Well Name: NUGGET 6_31 FEDERAL COM	Well Location: T24S / R31E / SEC 7 / NENW / 32.2383094 / -103.8201514	County or Parish/State: EDDY / NM
Well Number: 11H	Type of Well: OIL WELL	Allottee or Tribe Name:
Lease Number: NMNM082904	Unit or CA Name:	Unit or CA Number:
US Well Number: 3001555865	Operator: OXY USA INCORPORATED

Notice of Intent

Type of Submission: Notice of Intent	Type of Action: APD Change
Date Sundry Submitted: 01/30/2025	Time Sundry Submitted: 08:28
Date proposed operation will begin: 03/15/2025

Procedure Description: Oxy respectfully requests approval to change the surface hole location from 293' FNL & 1702' FWL Section 7, T24S, R31E to 418' FNL & 1582' FWL Section 7, T24S, R31E; as well as the bottom hole location. Also included is the blanket A casing design. There will be no additional surface disturbance related to this sundry.

6. Wellbore Diagram(s)

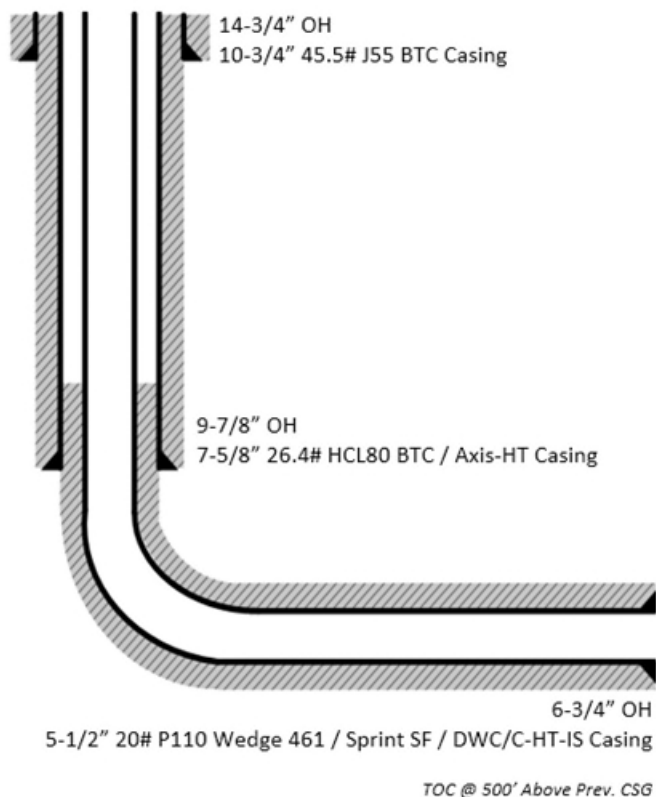
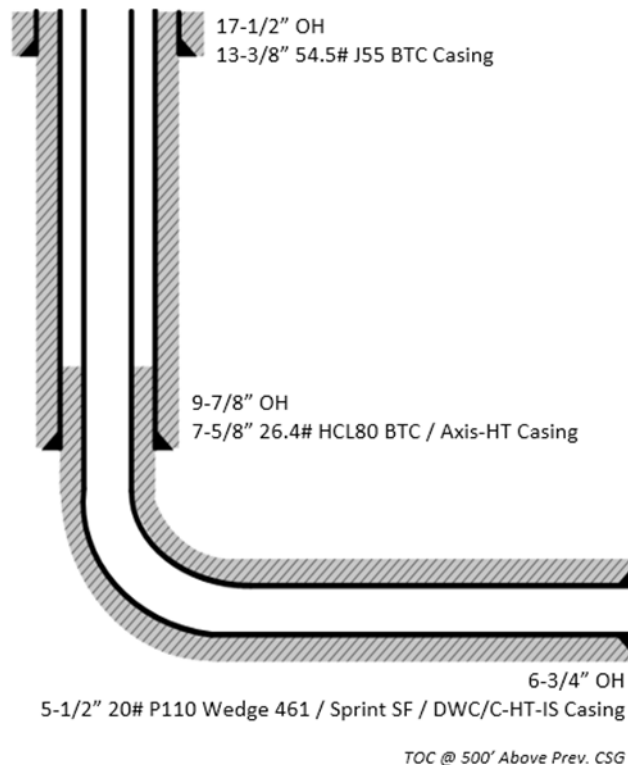
NOTE: WELL APPROVED FOR DESIGNS A1 AND A2. REVIEW CEMENT VOLUMES TO ACHIEVE TIE BACKS LISTED BELOW.

WELL IS CLOSE TO THE R111Q BOUNDARY. PLEASE DIRECTIONALLY MAINTAIN THE WELL AS PROPOSED AND AWAY FROM R111Q POTASH AREA UNTIL THE SALT INTERVAL IS CLEARED.

1. The **10-3/4** inch surface casing shall be set at approximately **856** feet (a minimum of 25 feet (Lea County) into the Rustler Anhydrite, above the salt, and below usable fresh water) and cemented to the surface.

- d. If cement falls back, remedial cementing will be done prior to drilling out that string.
2. The **7-5/8** inch intermediate casing shall be set at approximately **8820** feet. **KEEP CASING 1/2 FULL FOR COLLAPSE SF. PRESSURE TEST NEEDS EXTERNAL PRESSURE REVIEW AS WELL.** The minimum required fill of cement behind the **7-5/8** inch intermediate casing is:

3. The 5-1/2 inch production casing shall be set at approximately **20,064** feet. The minimum required fill of cement behind the 5-1/2 inch production casing is:

1. The 13-3/8 inch surface casing shall be set at approximately **856** feet (a minimum of 25 feet (Lea County) into the Rustler Anhydrite, above the salt, and below usable fresh water) and cemented to the surface.

- h. If cement falls back, remedial cementing will be done prior to drilling out that string.
2. The 7-5/8 inch intermediate casing shall be set at approximately **8820** feet. **KEEP CASING 1/2 FULL FOR COLLAPSE SF. PRESSURE TEST NEEDS**

EXTERNAL PRESSURE REVIEW AS WELL. The minimum required fill of cement behind the **7-5/8** inch intermediate casing is:
